UNITED STATES PATENT AND TRADEMARK OFFICE

APPLICATION NO.	FILING DATE	FIRST NAMED INVENTOR	ATTORNEY DOCKET NO.	CONFIRMATION NO.
10/821,860	04/12/2004	Federico Cabrele	713-1121	1818

Office Action Summary

DETAILED ACTION

Vernot:

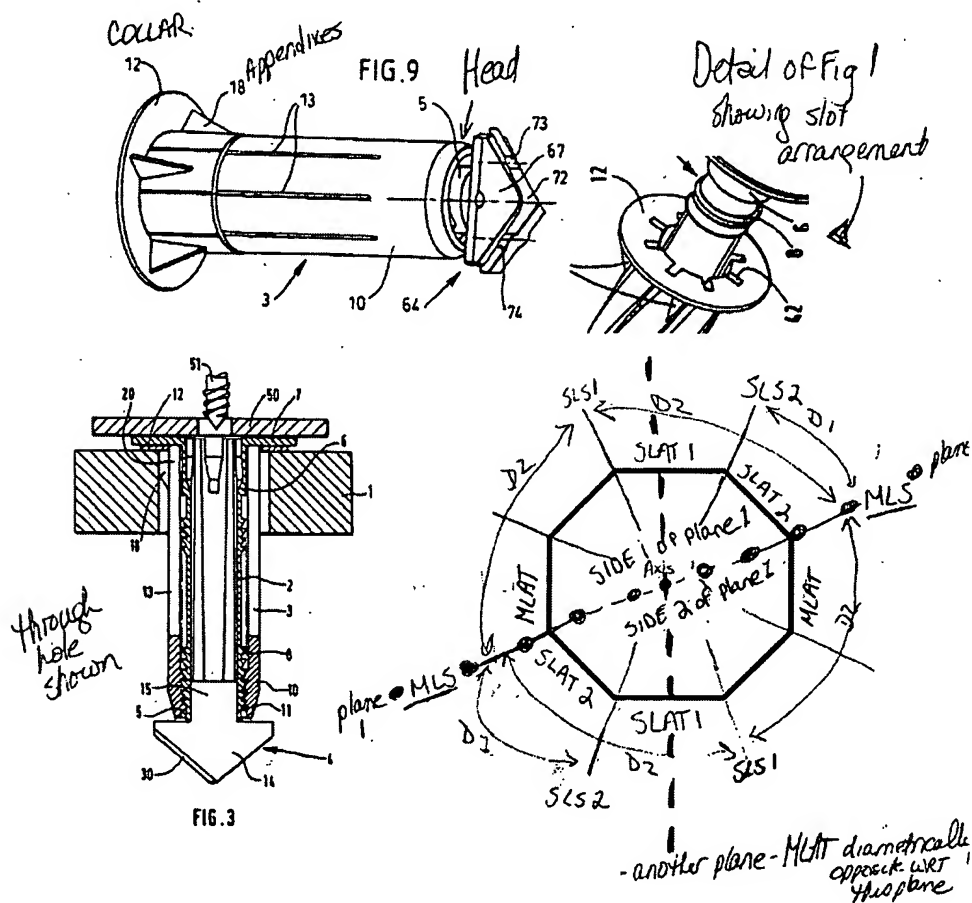
Explanation of marked up drawing: Pairs of main longitudinal slots (MLS) define main longitudinal anchoring tongues (MLAT) (strip between two "13's". There are 8 equally-spaced slots "13" (see detail of Fig 1 below) - examiner has labeled an octagon below, with each corner representing a slot, with which slots are considered main MLS and which are considered secondary SLS.

Re claim 8: Referring to the numbering by examiner of the octagonal shape, representing the collar with 8 slots of Vernet, there are 4 SLS arranged in 2 pairs that are arranged in mirror image relationship with each other, and the SLS of each pair are parallel.

Re claim 14: Deformable main longitudinal anchoring tongues (MLAT) are arranged diametrically opposite one another with respect to the longitudinal axis of the anchor, and secondary longitudinal anchoring tongues (SLAT) are arranged in essentially mirror image pairs in which each pair is arranged diametrically opposite the longitudinal axis. (see marked up drawing above). However, Vernet does not disclose

FIG. 1

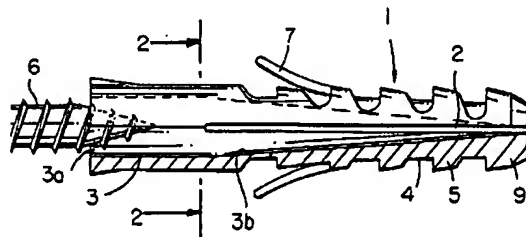
Fischer et al teach an expanding screw anchor 1 having a longitudinal slots 2 forming main longitudinal anchoring tongues (see Fig 1 below). These tongues have a substantially serrated profile, which is described in col 3 lines 13-19 as advantageous:

Fischer et al teach an expanding screw anchor 1 having a longitudinal slots 2 forming main longitudinal anchoring tongues (see Fig 1 below). These tongues have a substantially serrated profile, which is described in col 3 lines 13-19 as advantageous:
